Re: Paric Corporation Project No. 15051
15051-Webster University Interdisciplinary Science Building
CP-068 - ASI#41 - Access Control System changes

Architect's Supplemental Instructions

Architect's ASI No: 041

Project:
Webster University
Interdisciplinary Science
Building

T0101.A

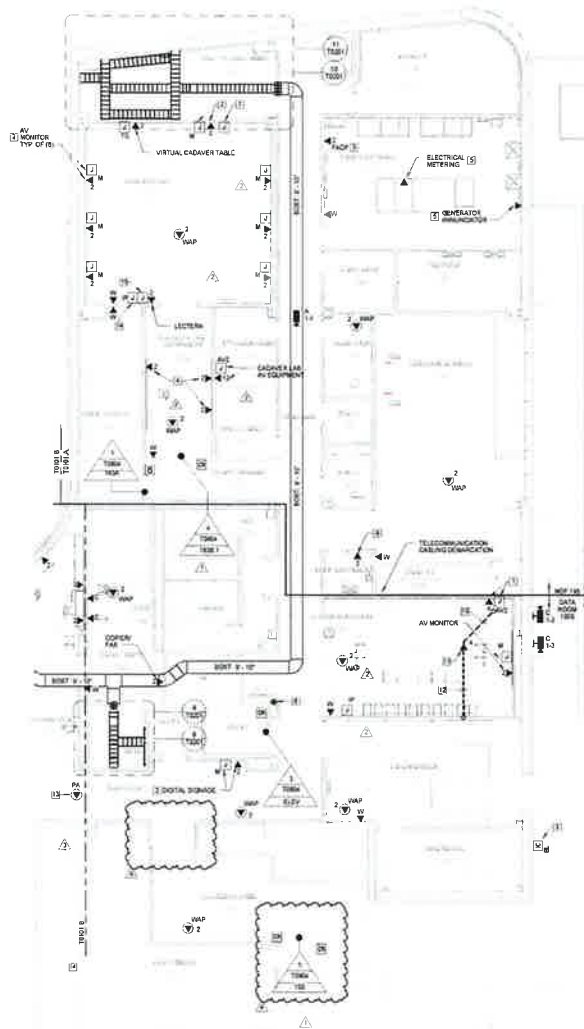
1. T0101.A – LEVEL 01 FLOOR PLAN – AREA B
 - A. Relocated access control equipment from door 170 to door 150.
2. T0803 – ACCESS CONTROL BLOCK DIAGRAMS
 - A. Revised Level 1 block diagram
3. T0804 – ACCESS CONTROL DETAILS
 - A. Revised Door Interface Boxes
 - B. Revised Access Control System cable
 - C. Revised General Notes
 - D. Revised Responsibility matrix

T0803

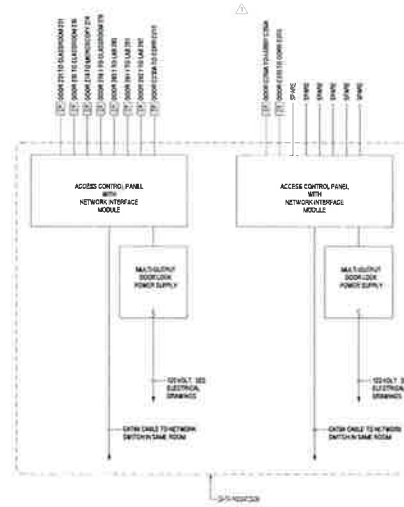
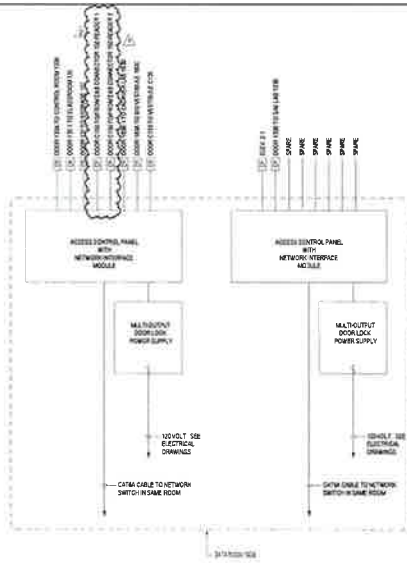
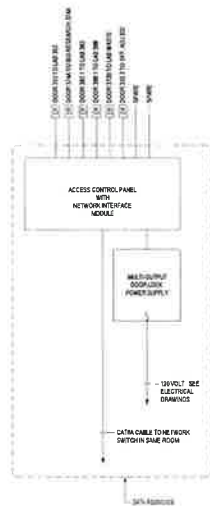
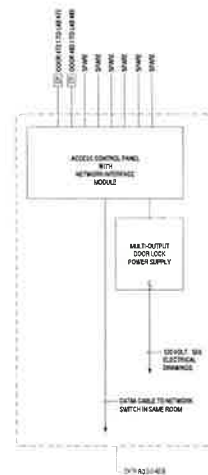
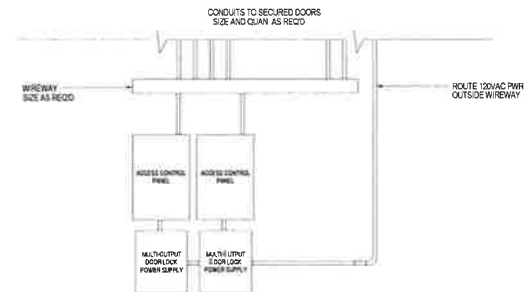
REVISED ENTIRE SHEET
